FIRE SAFETY INSPECTION REPORT

Factory Name: Wucho Fashion Ltd.

ACCORD ID: 23189

Date: 3rd May, 2018

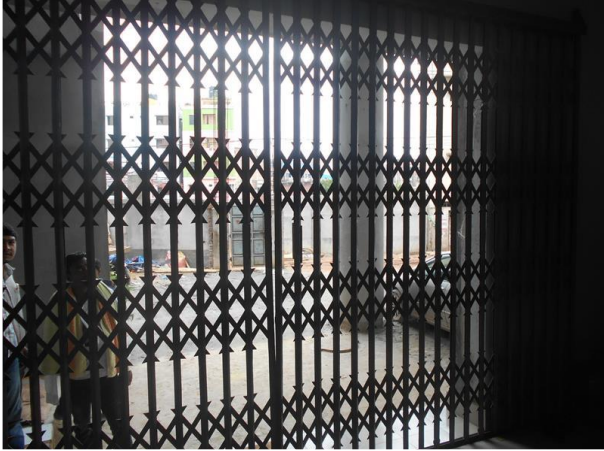
8	Fire Rated Construction	Dinning space is not separated from storage area by Fire rated construction.	Remove dinning space from this location or, alternatively, provide minimum 3-hour fire rated separation.	Within 3 months

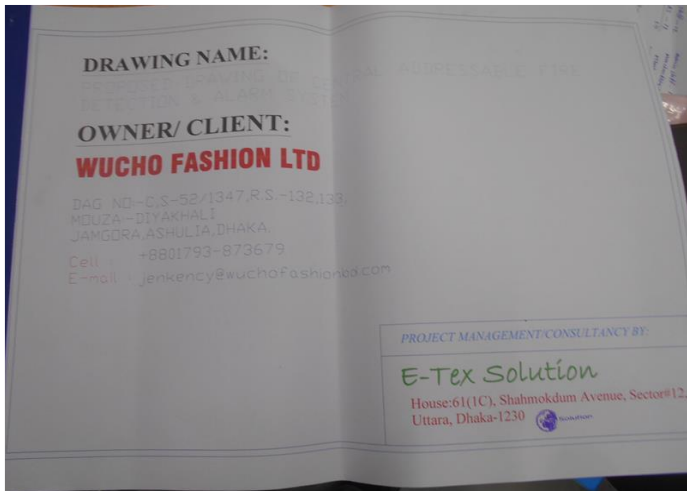
SI No.	Category	Findings	Required Action	Remediation Time Frame
18	Egress	Storage was located in the exit stairs. Location: diesel machine underneath north stair at ground floor and other types of storages were found in all stairs throughout all floors.	Remove all storage from exit stairs.
